From: noreply@feedback.planningportal.nsw.gov.au on behalf of [Planning Portal - Department of Planning and Environment](#)
To: [DPIE PDPS Glenfield Precinct Mailbox](#)
Cc: [DPE PS ePlanning Exhibitions Mailbox](#)
Subject: Draft Glenfield Place Strategy
Date: Thursday, 11 February 2021 12:11:58 PM
Attachments: [210211---glenfield-submission.pdf](#)

Thank you for the opportunity to make a submission on the proposed Glenfield Place Strategy.

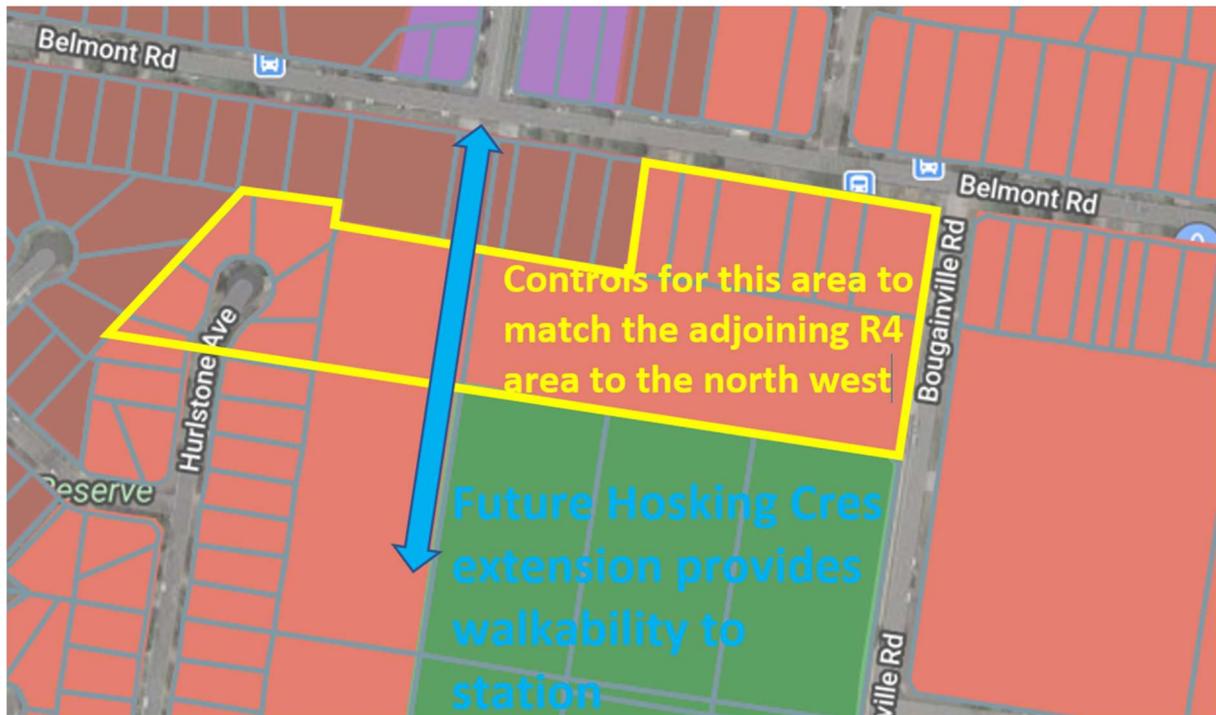
Aside from this, I would like to note an issue in relation to strata titled land, particularly in the vicinity of Glenfield Park.

The draft "Glenfield Precinct – Land Use and Infrastructure Analysis (2015)" identified locations of strata title land and correctly noted these as a constraint to redevelopment. The constraints to redevelopment posed by strata titled land are that:

1. Any redevelopment of a site would require the consent of all (or at least a large percentage) of owners, rather than one single owner on a standard torrens title lot.
2. The strata titled land in the study area is already developed to a higher density than the surrounding standard torrens title lots, making it far less financially feasible to redevelop these sites.

I don't believe the proposed zoning, building height and FSR controls for the strata titled land surrounding Glenfield Park will achieve the vision for additional dwellings by 2040, as it does not provide the financial feasibility incentive to redevelop these sites.

Specifically, for the area adjoining Glenfield Park to the north (refer image below), it is justified to increase the zoning/height/FSR controls to that of the adjoining R4 area to the north west due to:

1. It is located within 400m from the Glenfield train station. The proposed extension of Hosking Crescent along the western perimeter of Glenfield Park will provide faster and more direct pedestrian access to the train station than other areas marked for R4 zoning in the current proposal.
2. It is located in an area of high amenity adjoining a large open space area.
3. Additional dwellings adjoining Glenfield Park will provide an increase in passive surveillance of the park in order to assist in minimizing undesirable activities.
4. Any overshadowing concerns can be addressed by way of development controls.
